Proposal for Supplement 8 to the 04 series of amendments to Regulation No. 44

The text reproduced below was prepared by the expert from Spain on behalf of the Technical Services Group (TSG) on Regulation No. 44. The modifications to the current text of Regulation are marked in bold for new or strikethrough for deleted characters.

Figure 1a
Two-point static belt

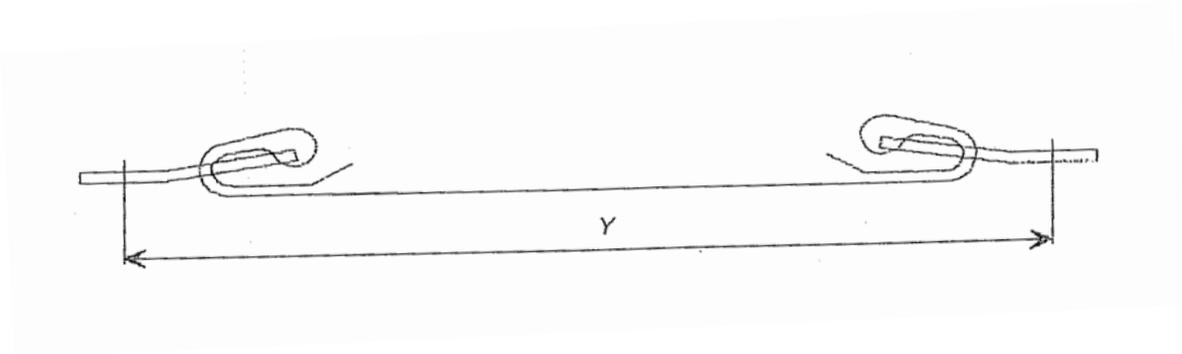
"5. The two-point static belt as shown in Figure **1a** consist of ...

6. ...The value of Y in Figure **1a** is ..."

Figure 1, amend to read:

Annex 13, paras. 5 and 6 and new Figure 1a.:

Text correction to refer to the right figure. The figure of standard lap belt was missing.

Figure 1b
Three-point retracting belt

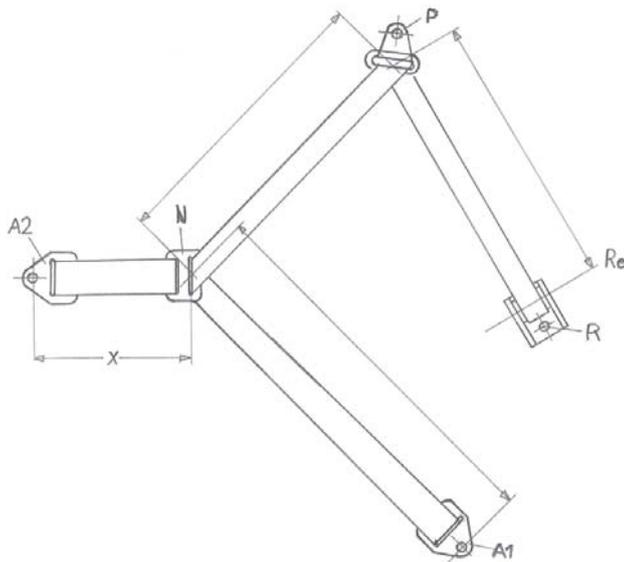
"2. The three-point retracting belt has the following rigid parts: a retractor (R), a pillar loop (P), two anchorage points (A1 and A2) (see Figure **1b**)...

The value of X in Figure **1b** below..."
